This is in reference to your application for a building permit for a new deck at the rear of your residence on Peaks Island in the IR-2 Island Residence Zone.

Mortgage Inspection for MAURICE A. SELINGER,
PEAKS ISLAND PORTLAND MAINE

SELINGER	PAGE 1 OF 4
PEAKS ISLAND, ME	
DECK	20' x 12'-6"
DATE: JUNE 25, 89	SCALE: 1/2" = 1'-0"

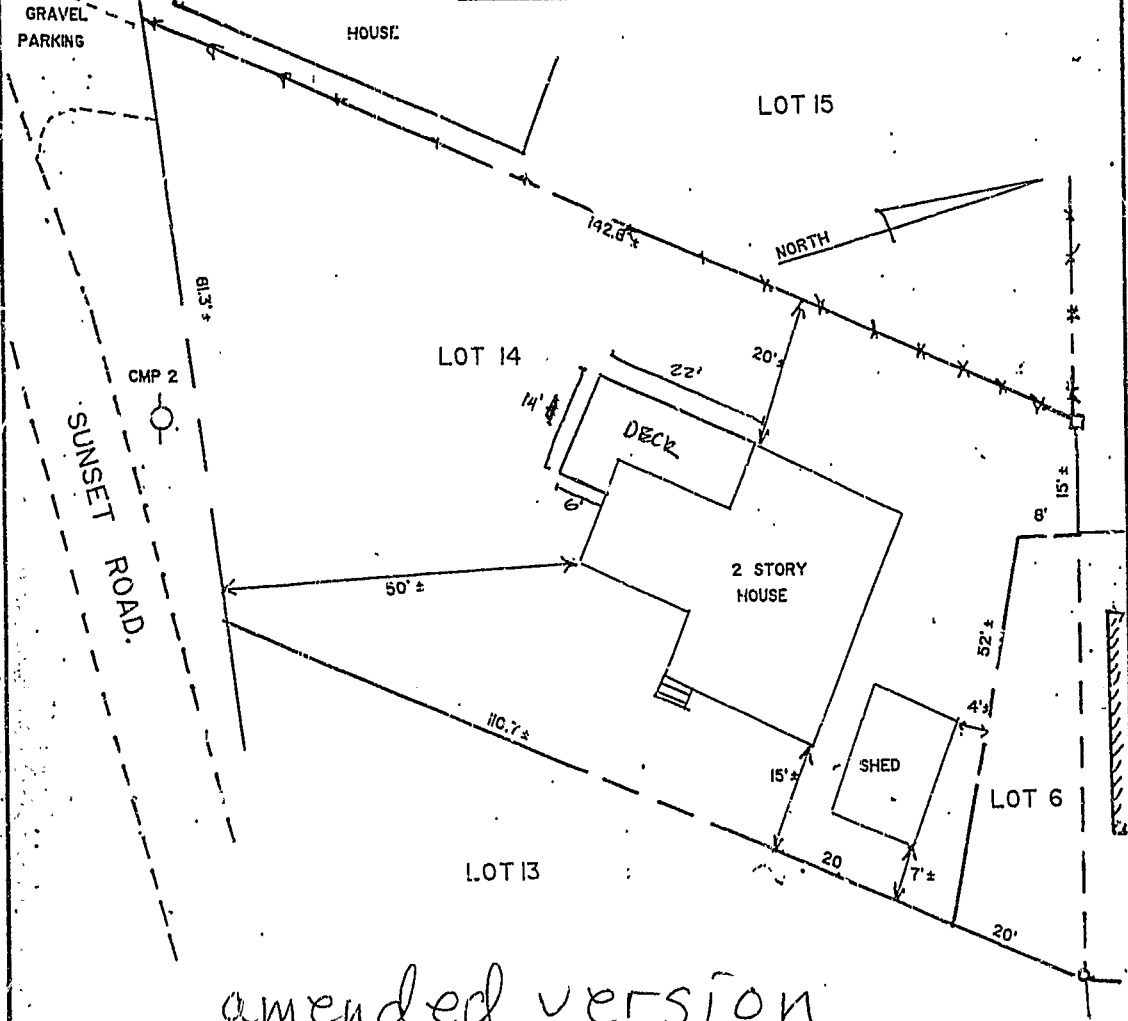
It appears from the proposed plot plan which you submitted that the proposed deck does not meet the side yard setback of 20 feet as required by the IR-2 Zone, in Section 14-145.11 (3)c of the City Zoning Ordinance.

Based upon the above setback requirements, the size of your proposed deck should be reduced from 12 feet to 10 feet in depth in order to maintain the 20 foot side yard setback requirement of the Zoning Ordinance. Please revise your plot plan to conform with this zoning requirement for side yard setback.

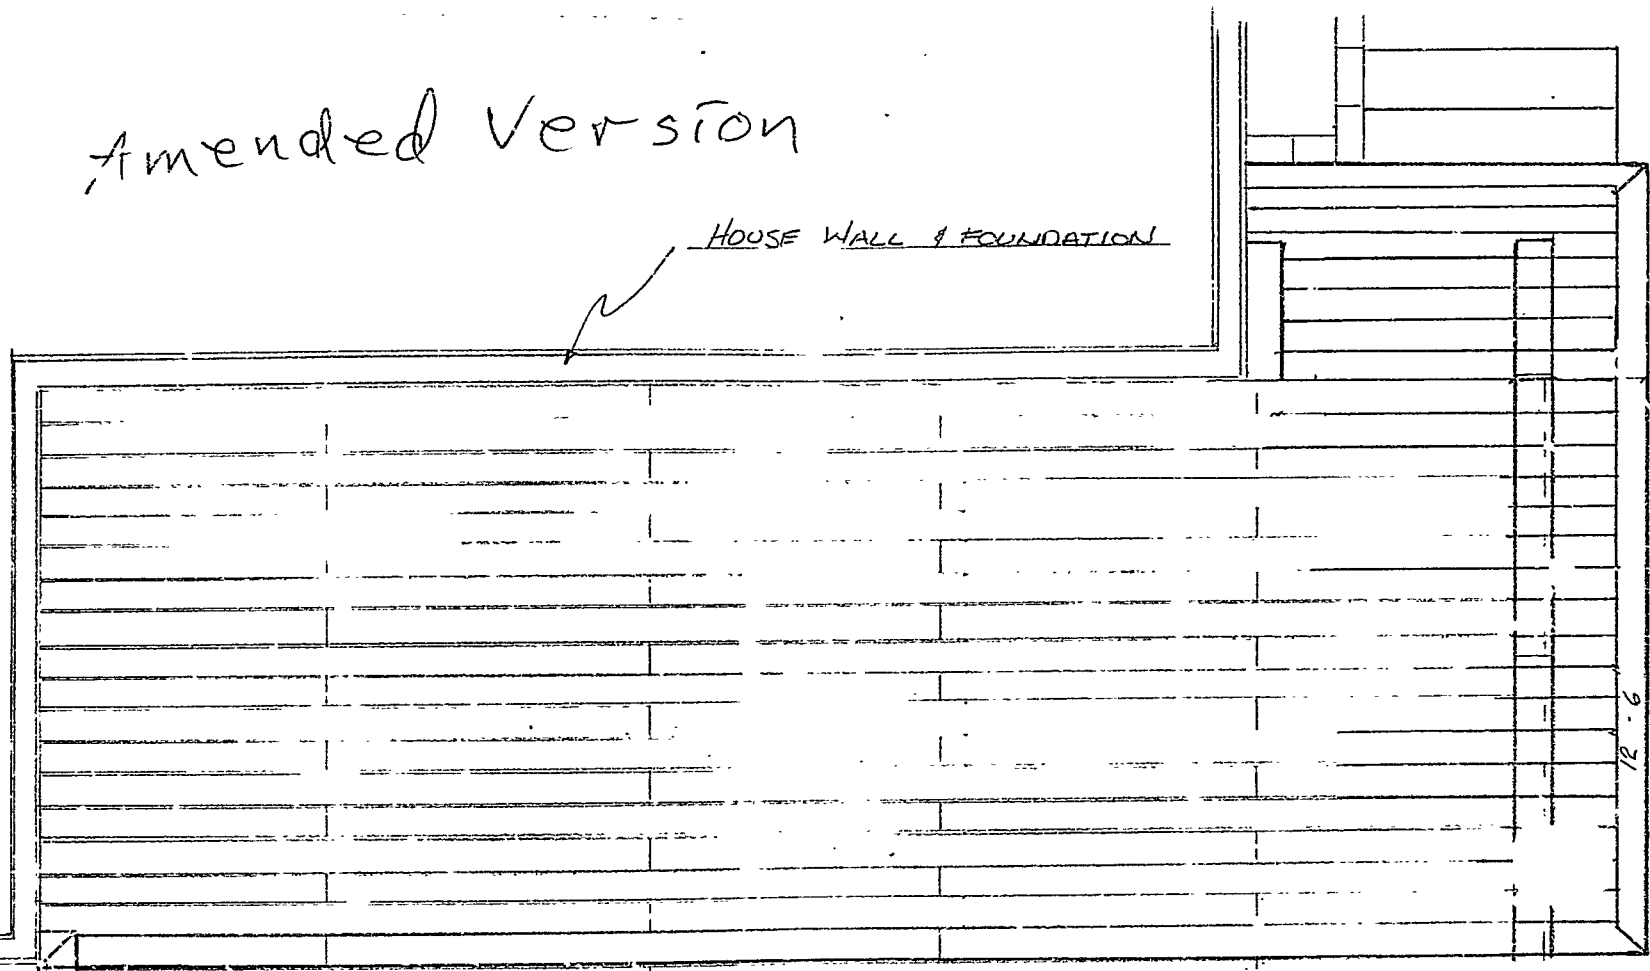
It appears from the proposed plot plan which you submitted that the proposed deck does not meet the side yard setback of 20 feet as required by the IR-2 Zone, in Section 14-145.11 (3)c of the City Zoning Ordinance.

Based upon the above setback requirements, the size of your proposed deck should be reduced from 12 feet to 10 feet in depth in order to maintain the 20 foot side yard setback requirement of the Zoning Ordinance. Please revise your plot plan to conform with this zoning requirement for side yard setback.
